# Development Review Committee

## Approved Minutes

Pre-Application, PL201700233

Project	900 unit Self-storage building at 101 West American boulevard
Site Address	101 American Boulevard West
Plat Name	REGISTERED LAND SURVEY NO 861;
Project Description	Conditional Use Permit for a three story, 900 unit, 116,460 square foot self-storage and a preliminary and final plat to create a platted parcel.
Application Type	Conditional Use Permit Type III Preliminary or Final plat
Staff Contact	Nick M. Johnson <a href="mailto:nmjohnson@bloomingtonMN.gov">nmjohnson@bloomingtonMN.gov</a> , (952) 563-8925
Applicant Contact	Josh Davis, Vice President of Pamlico Investments (720) 800-2142 <a href="mailto:josh@pamlicoinvest.com">josh@pamlicoinvest.com</a>
Developer	
Post Application DRC	YES

# AMERICAN BOULEVARD STORAGE

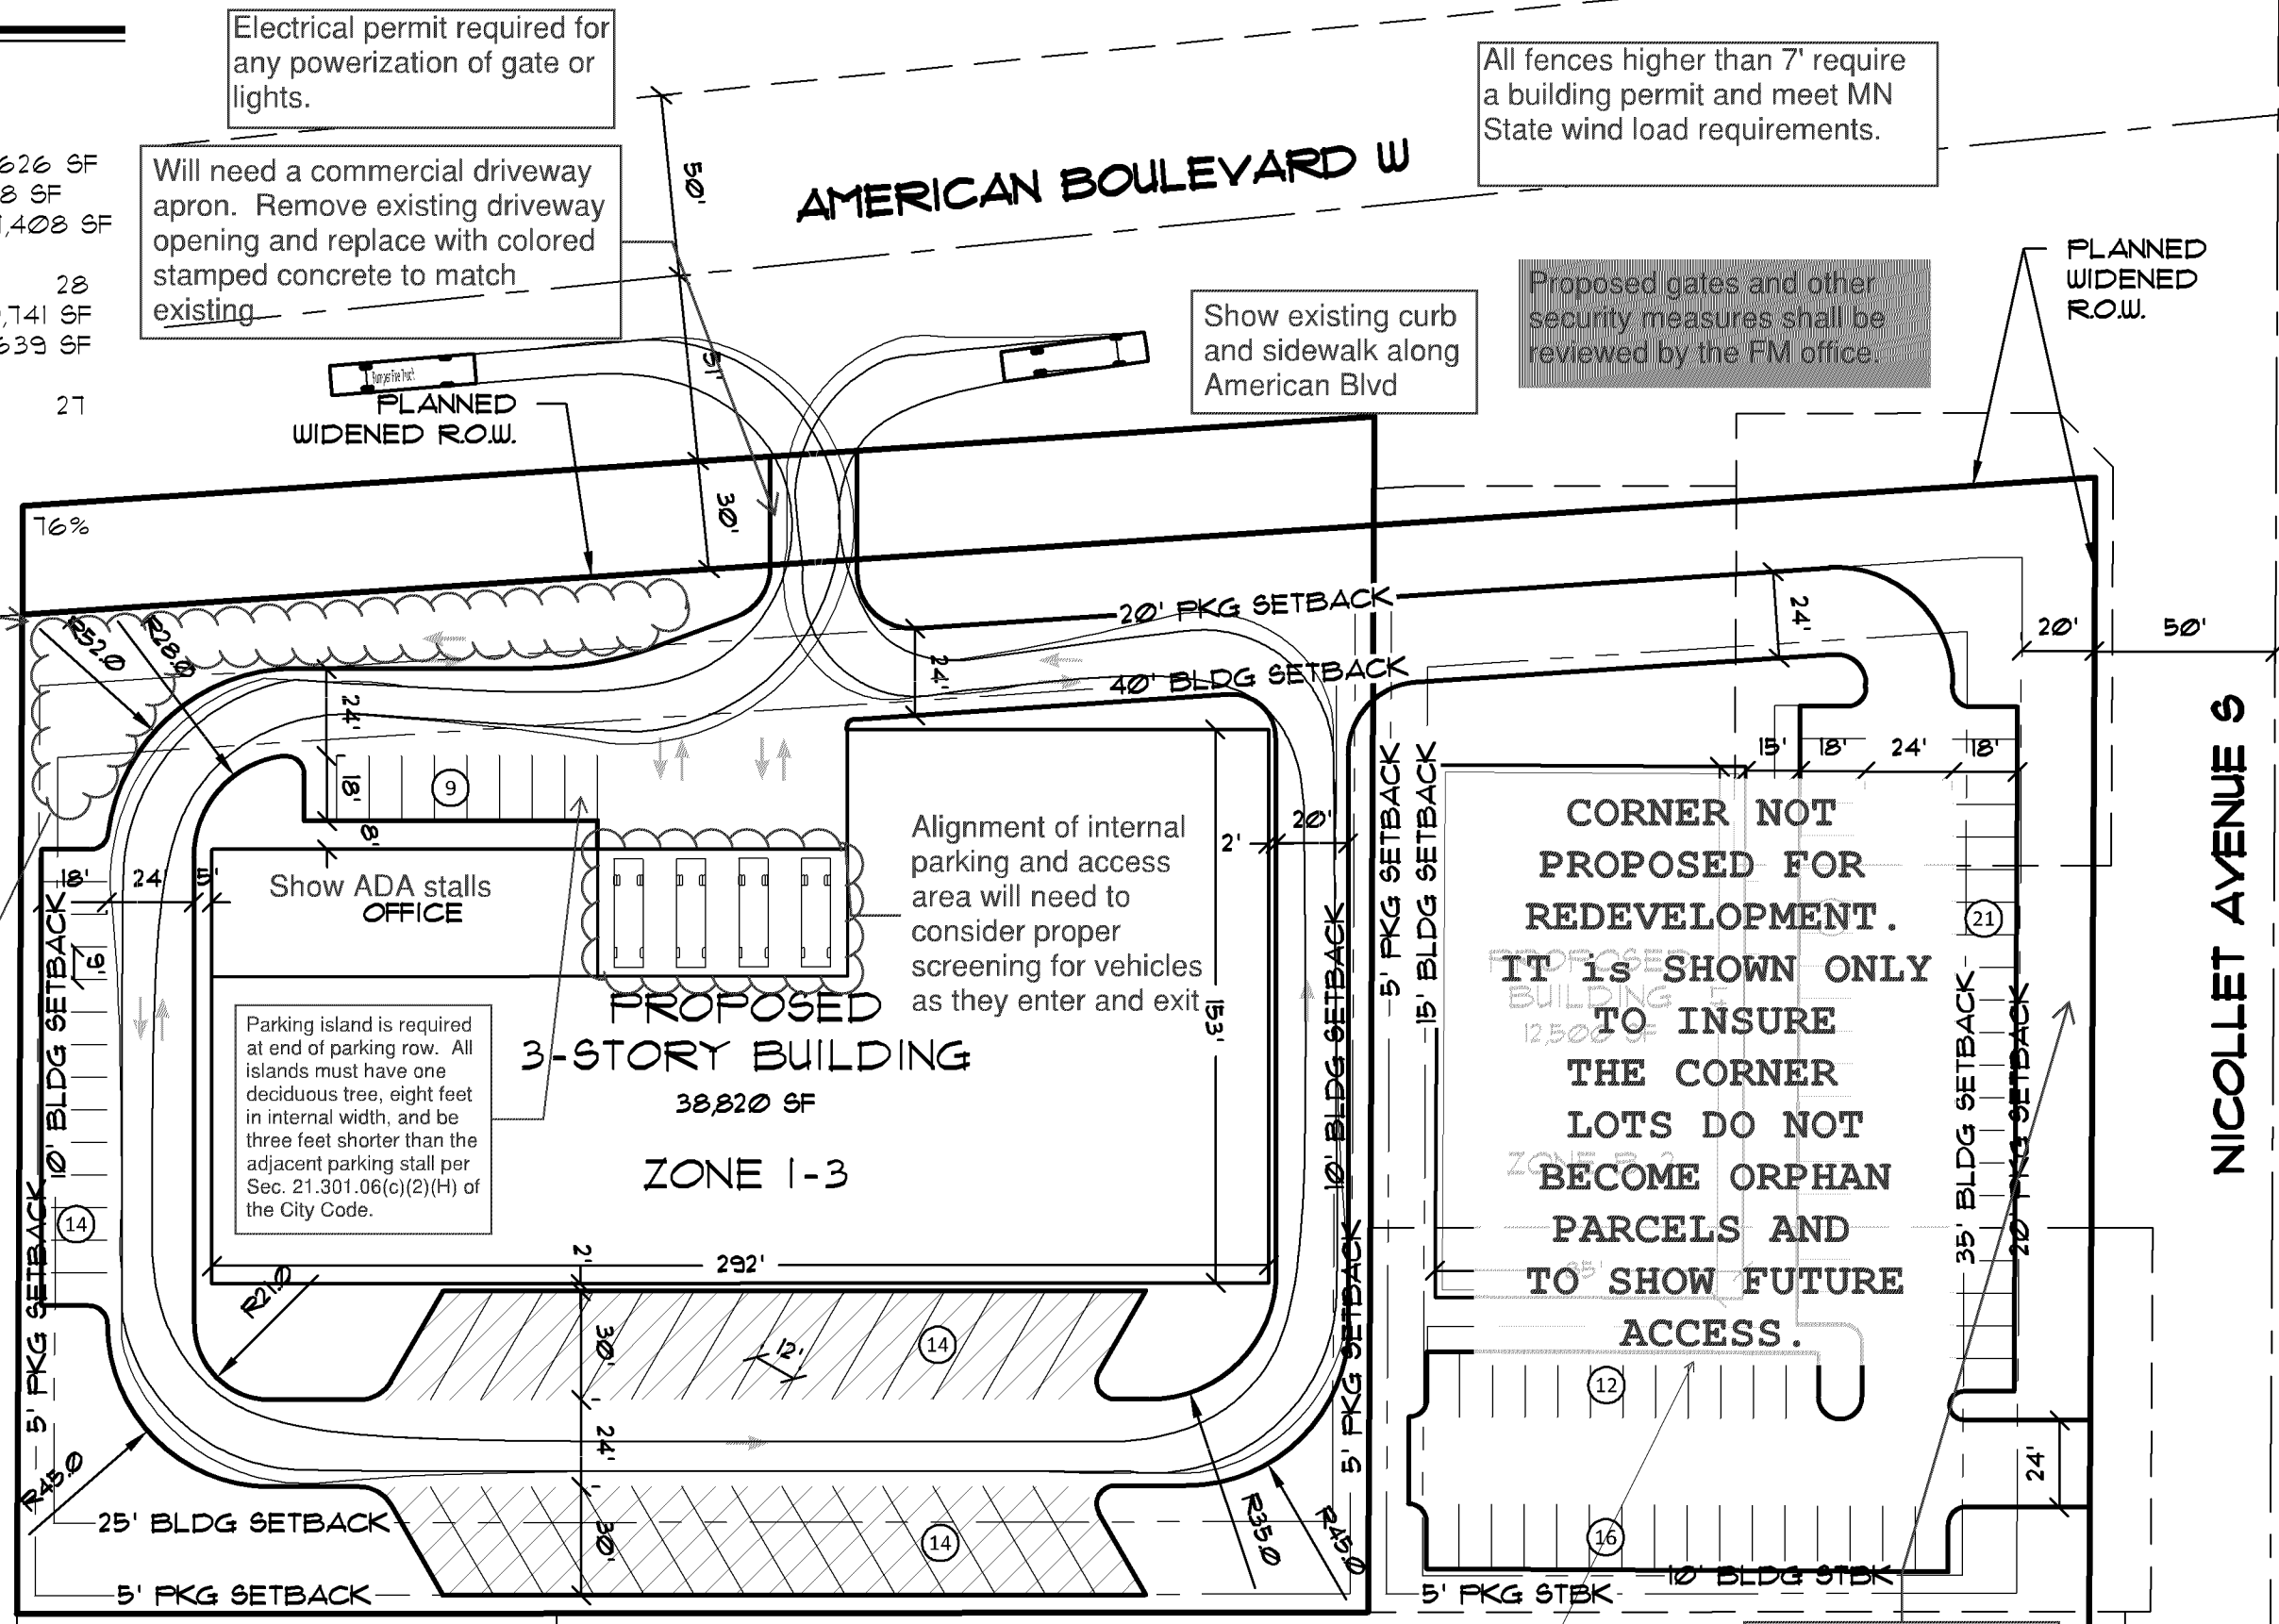
10' sidewalk/bikeway easement desired

A three-foot high screen for parking areas adjacent/visible to public streets is required (Sec. 19.52(d)(3-4)).

Electrical permit required for any powerization of gate or lights.

Will need a commercial driveway apron. Remove existing driveway opening and replace with colored stamped concrete to match existing.

All fences higher than 7' require a building permit and meet MN State wind load requirements.

Show existing curb and sidewalk along American Blvd

Proposed gates and other security measures shall be reviewed by the FM office.

Parking island is required at end of parking row. All islands must have one deciduous tree, eight feet in internal width, and be three feet shorter than the adjacent parking stall per Sec. 21.301.06(c)(2)(H) of the City Code.

Alignment of internal parking and access area will need to consider proper screening for vehicles as they enter and exit.

If corner will not be redeveloped, linetypes will need to be adjusted to differentiate future development vs. currently proposed

In future, sidewalk will need to move so it is not curb walk.

# AMERICAN BOULEVARD STORAGE

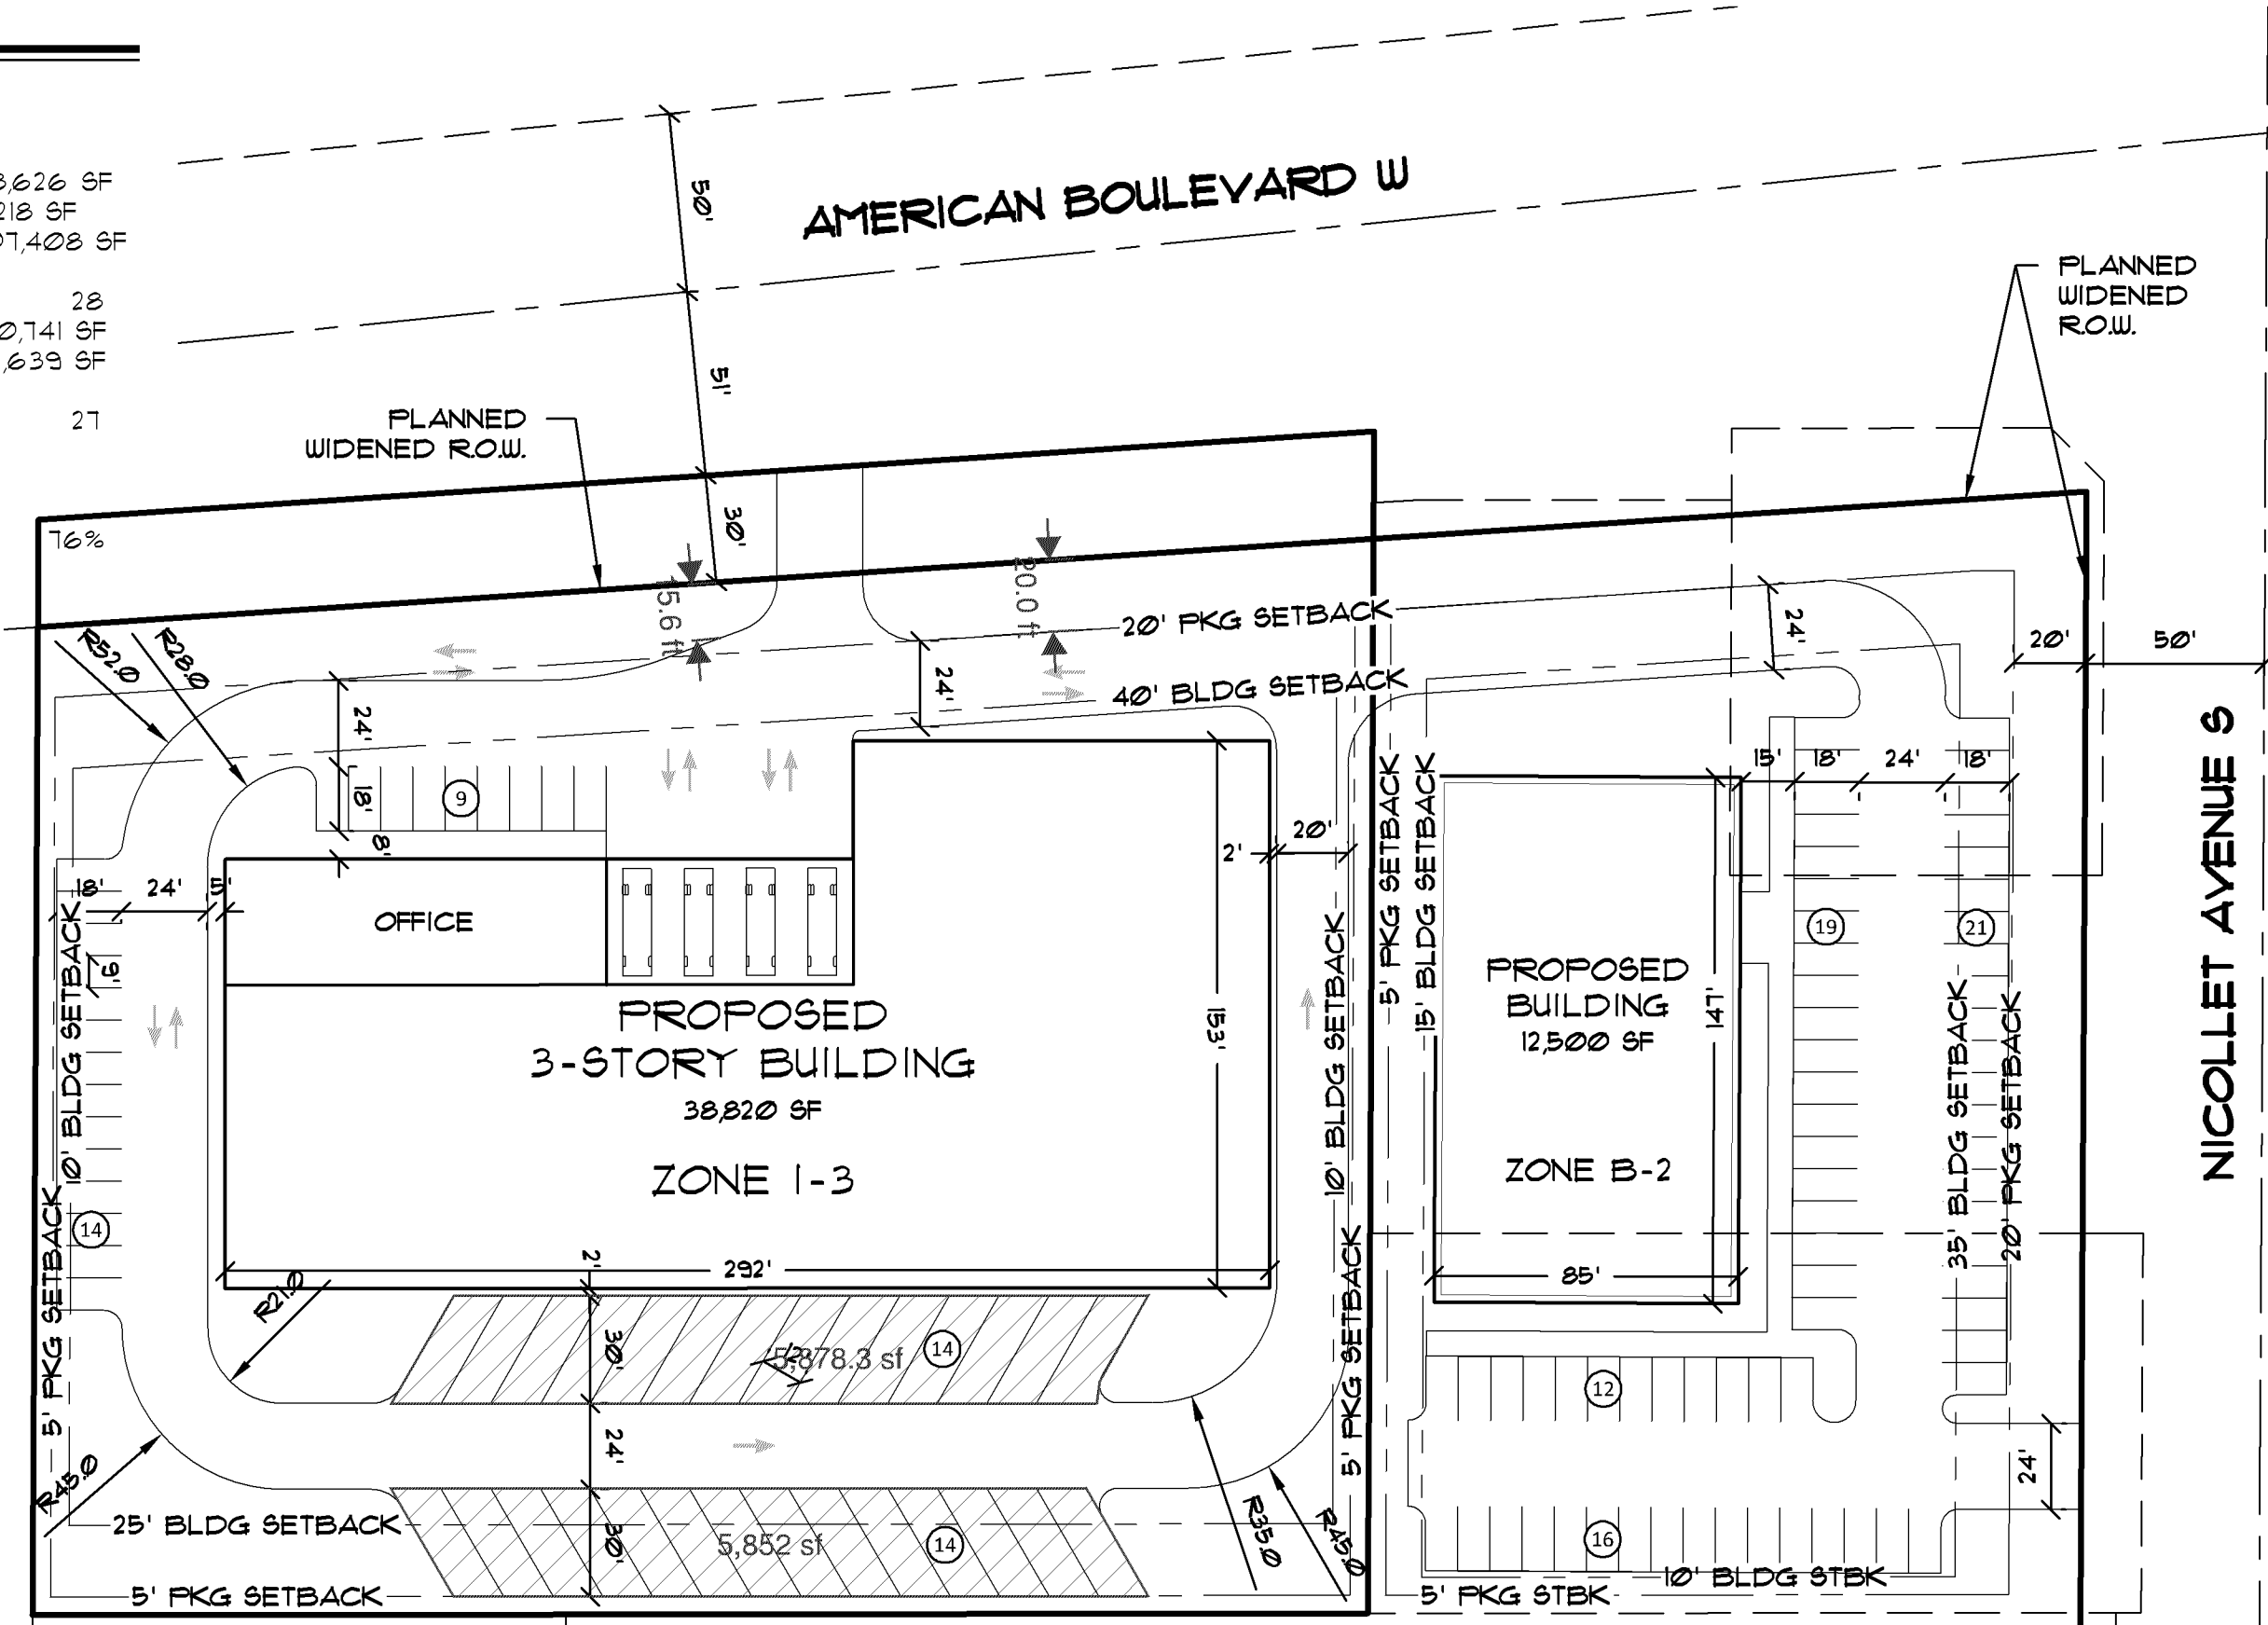
Will need to provide further building information for more detailed Plan Review.
